LAA/AWA/13/08
5th November 2013

All Jabiru Series Aircraft

Main Undercarriage Bolts Inspection/Replacement/Mandatory Life

Fig. 1. General arrangement of the Jabiru Undercarriage

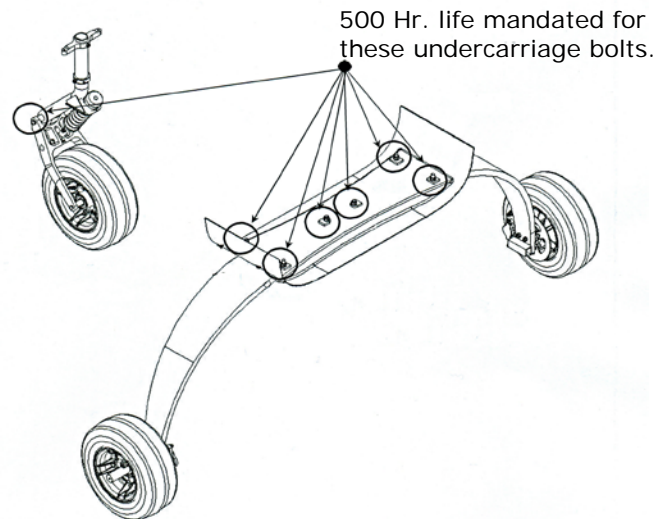
LAA Engineering has recently issued an Airworthiness Information Leaflet (AIL) extending, to all Jabiru types, the requirement to replace any remaining 5/16" (AN5) main undercarriage attachment bolts with 3/8" (AN6) bolts and mandates a 500 hr. life for these bolts as per JSB 025-2 (7th May 2009).

It has been found that the main undercarriage bolts on all Jabiru aircraft are prone to loosening; Operators must regularly check main undercarriage legs in service; this can be achieved by getting an assistant to lift the appropriate wing-tip and check that there is no fore/aft. movement in the leg.
